CITY OF ELBERTON**SPLASH PAD FACILITY**

Engineer's Project No. 448-10A

ADDENDUM NO. 2

January 10, 2025

PROVIDE ACCESSORIES EQUAL TO MAKE & MODEL LISTED.

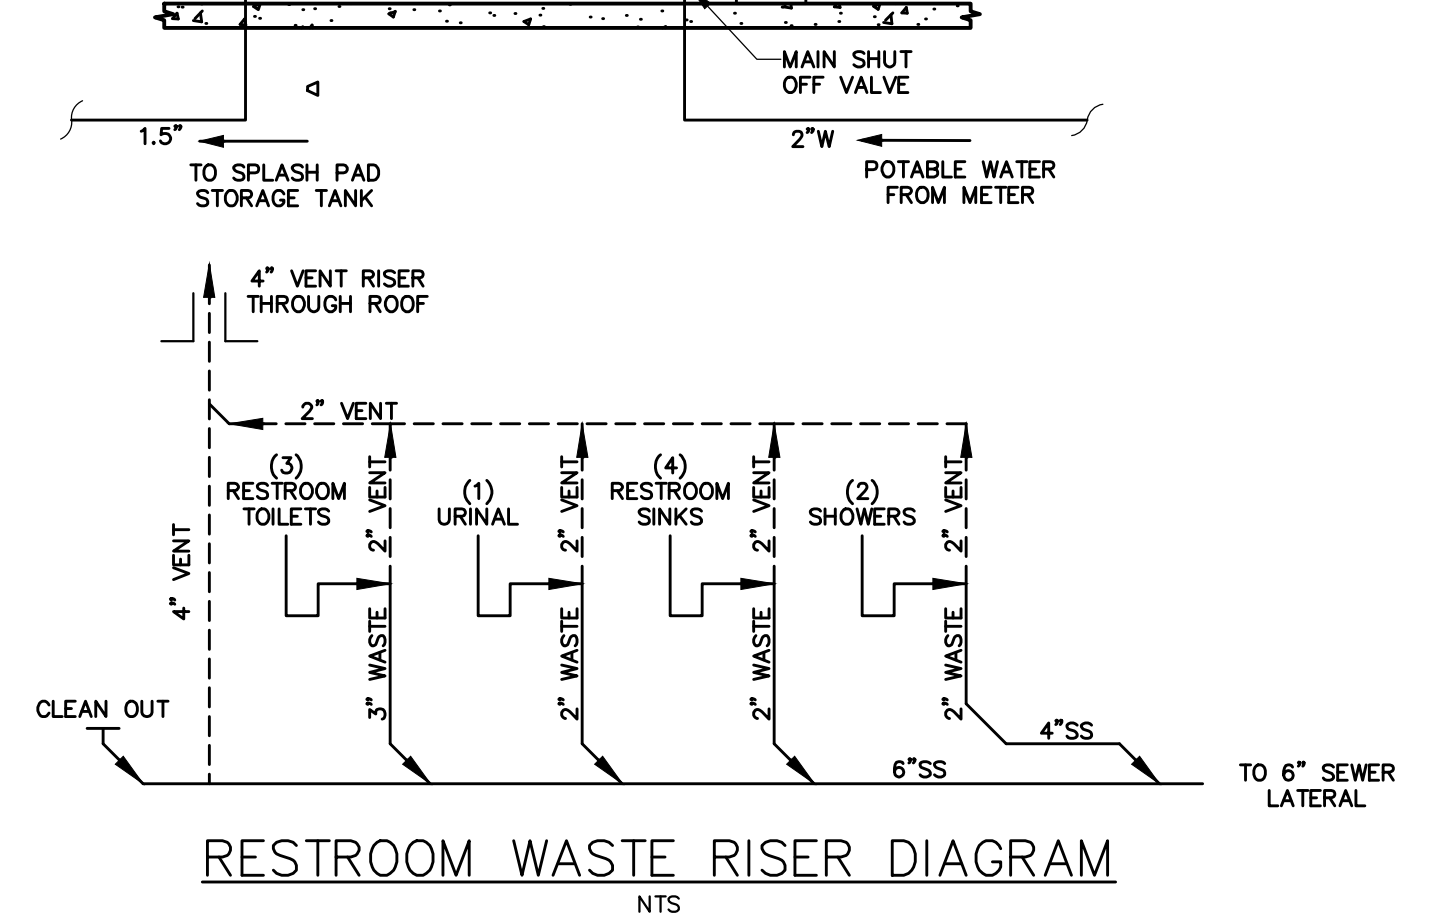
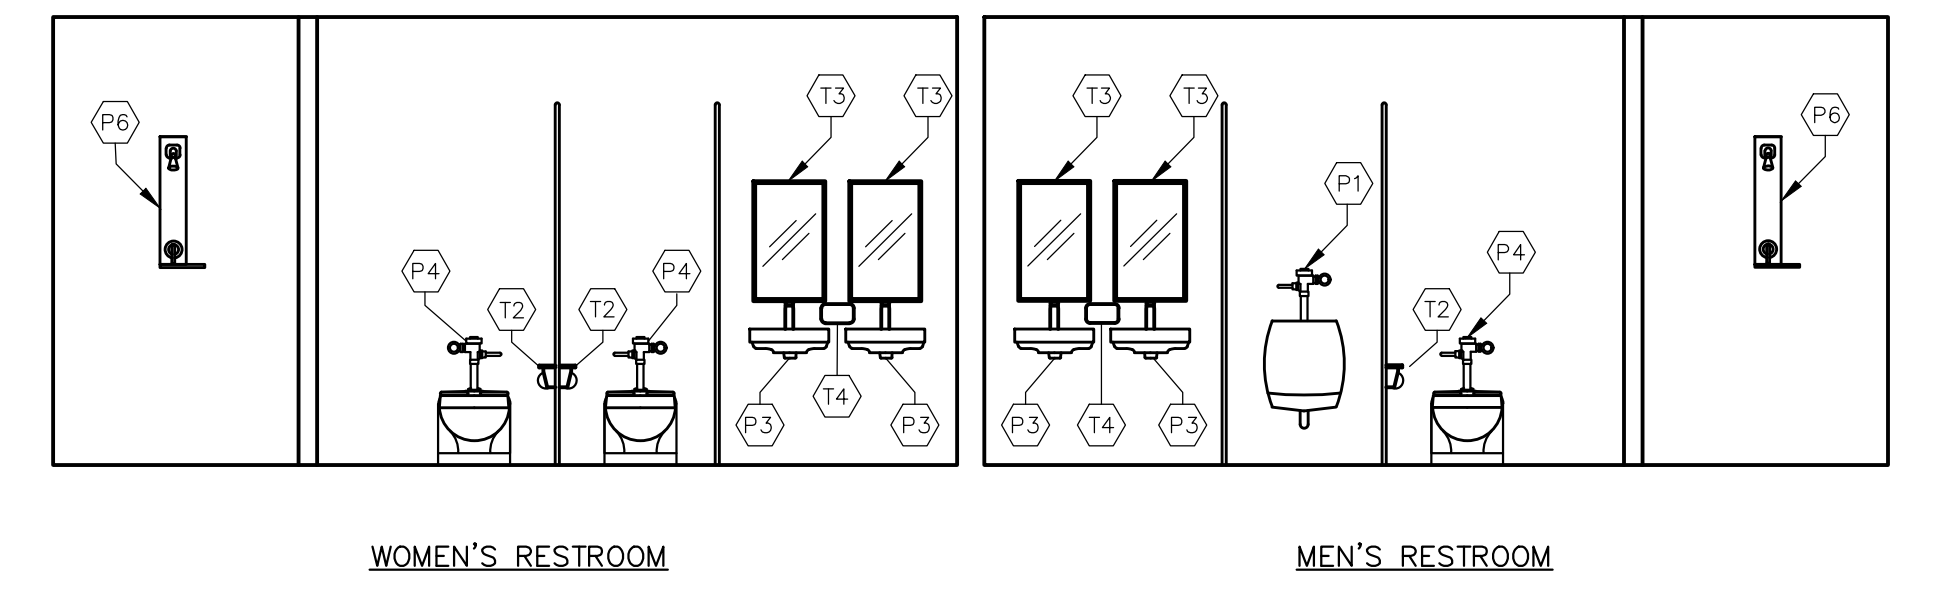
2. Page 16 does not show a drain in the pit. Will this be required?

6. Page 16 does not show a water fountain. Is one required?

- Fire panel location should be coordinated with the Owner. See construction notes on sheet 16.***
14. PL400 shows an eye wash station and states "by plumber." However, drawing 16 (plumbing) does not indicate an eye wash or a water line to supply it. Will an eyewash station and water line be required?

- Yes, an eye wash station with water line is required, see detail on sheet 16.***
15. PL403, Detail 6, shows a floor drain and instructions that are not indicated on the plumbing drawings. Will clarification be provided?

- See drain detail on sheet 16.***
16. PL403, Detail 6, needs a determination for the size of the drain line. What size is required?
- The drain line should be 4". See sheet 16.***

18. Will grab bars be required in the showers?
- Grab bars have been added to the three walls of the interior shower units, as shown on Sheet 16.***

22. There is no hose bib in the mechanical room. Will one be required?

No drain is required in the pit. The pit is sloped down at a rate of 0.125" per foot to facilitate the use of a sump pump per call out on sheets 13 and 14.

A stub out and valve should be installed on the waterline for future connection per callout on sheet 16.

See updated drawings on sheet 16.
